Access Compliance Report Public Rights-of-Way (Curb Ramps)

Main Street: CARBON_CANYON_RD		Cross Street: VALENCIA_AVE		Location:	SE
ADA ID: RPAT210920105215	Ramp Type:Type 1 - Perpendicular	Initial Pass/Fail: Pass	Overall Compliance: No	Severity Score:	2
Codes/Mitigation Info/Possible Solution			Field Measurements/Component Compliance

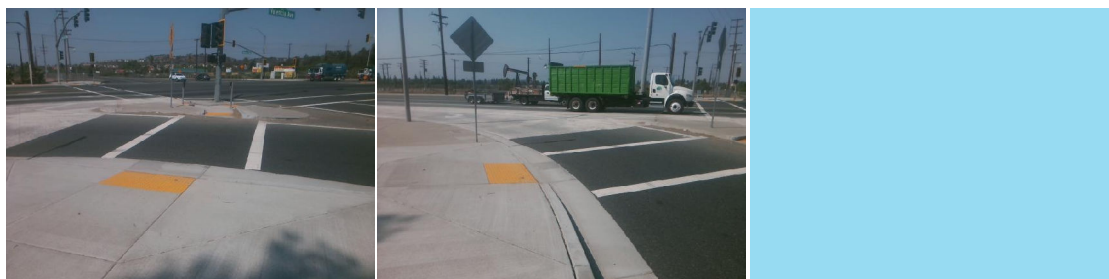
Yes	Ramp Inside Crosswalk 1	Yes	Yes	Ramp Inside Crosswalk 2	N/A
	Crossing 1 Slope (%)	3.2		Crossing 2 Slope (%)	N/A
	Crossing 1 Cross Slope (%)	1.2		Crossing 2 Cross Slope (%)	N/A
Yes	Gutter Ponding	No	No	Curb Slope	6.4
Yes	Gutter Lip Height (in)	0		Road Run Slope (%)	N/A
Yes	Gutter Run Slope (%)	2.7		Road Cross Slope (%)	N/A
Yes	Gutter Cross Slope (%)	2			
Yes	Overall Surface Condition: Acceptable		Yes	Perp Joint Present	Yes
	Cross Gutter Present?	No		Spandrel Present?	No
	Replace Cross Gutter?	N/A		Replace Spandrel?	N/A

Remove & Replace Curb Slope.

R304.2.2, STD 1115
